# Access Compliance Report

## Public Rights-of-Way

Intersection ID: 10100	Main Street: ASHLEY_RD	Cross Street: FREEDOM_DR	Location: E
ADA ID: 076CBA0D6D44	Ramp Type: Perp	Initial Pass/Fail: Fail	Overall Compliance: No
		Severity Score: 8.75

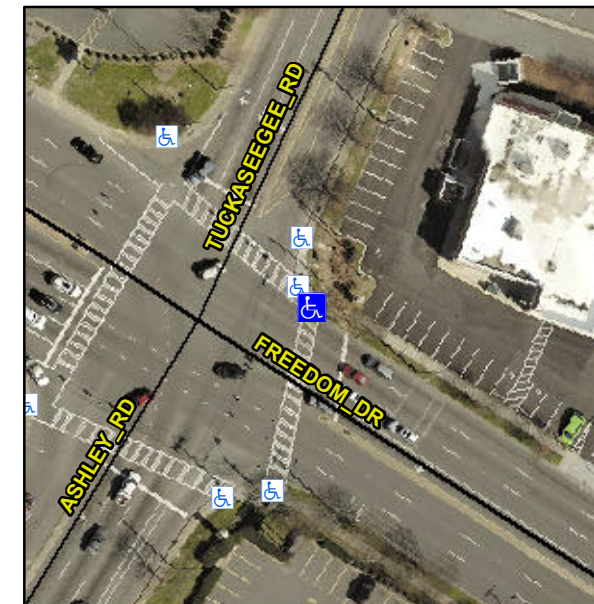
**Not Found, R304.5.1**

Compliance	Description	Data	Compliance	Description	Data
N/A	Ramp Length (in)	48.5	Yes	Ramp Slope (%)	6.9
No	Ramp Width (in)	47.5	Yes	Ramp XSlope (%)	2.0
N/A	Flare Type LT	N/A	N/A	Flare Type RT	N/A
N/A	Flare Slope LT (%)	N/A	N/A	Flare Slope RT (%)	N/A
N/A	Flare Traversable LT?	N/A	N/A	Flare Traversable RT?	N/A
N/A	Landing Length (in)	N/A	N/A	DWS Provided?	N/A
N/A	Landing Width (in)	N/A	N/A	DWS Contrast?	N/A
N/A	Landing Slope (%)	N/A	N/A	DWS Length (in)	N/A
N/A	Landing X Slope (%)	N/A	N/A	DWS Full Width?	N/A
N/A	Landing Curb? (Y/N)	N/A	N/A	DWS Offset (in)	N/A
N/A	Shared Landing?	N/A			
N/A	Gutter Ponding?	N/A	N/A	Gutter Slope (%)	N/A
N/A	Gutter Lip Ht (in)	N/A	N/A	Gutter X Slope (%)	N/A
N/A	Painted X Walk1?	Yes	N/A	Painted X Walk2?	N/A
	X Walk 1 Direction	To SW		X Walk 2 Direction	N/A
N/A	X Walk 1 Width (in)	111.0	N/A	X Walk 2 Width (in)	N/A
	X Walk 1 Slope (%)	3.3		X Walk 2 Slope (%)	N/A
	X Walk 1 X Slope (%)	3.3		X Walk 2 X Slope (%)	N/A

**Remove & Replace Entire Ramp.**
